High Purity RO/DI Water Skid

Shop Drawing Submittal Review

Project Name: Webster University-**ISB**

PROJECT NAME: Webster University ISBLOCATION: St. Louis MissouriCLIENT PROJ. No.: N/AWES PROJ. No.: 607SPEC SECTION: 22 6700
Processed Water System
for Laboratory FacilitiesSUBMITTAL ITEM:: See Below -CONTRACTOR: ICON Mechanical.CTR. SUBMITTAL # 22 6700-006 REV002SUBMITTAL DATE: December 19, 2016DATE RECEIVED: December 20, 2016RECEIVED VIA: E-MailRECEIVED FROM: WTADATE RETURNED: DECEMBER 20, 2016RETURNED VIA: E-MAILRETRURNED TO: WTASHOP@WMTAO.COM

'MRO-4V' & 'MRO-4H' Reverse Osmosis Systems

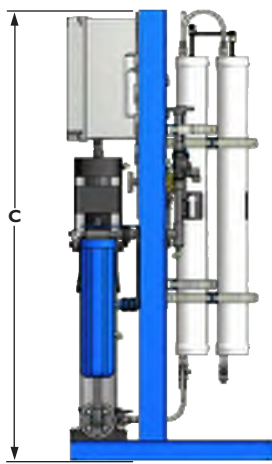
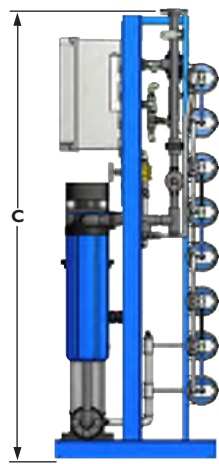
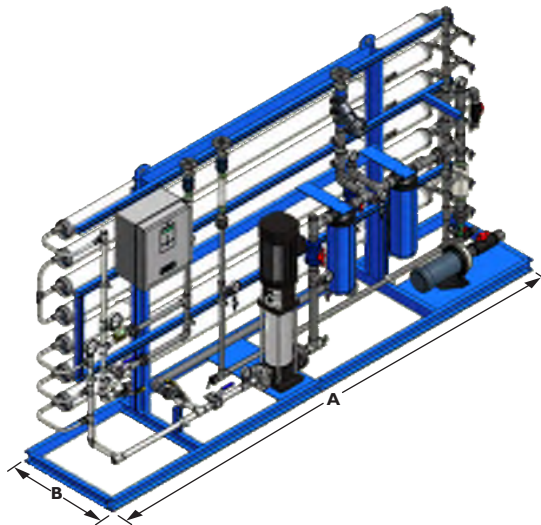
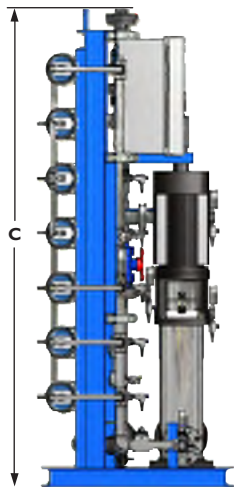
Verify assembly includes items and components as specified. Refer to specification section 226700, 2.2 - paragraph 7 in its entirety.
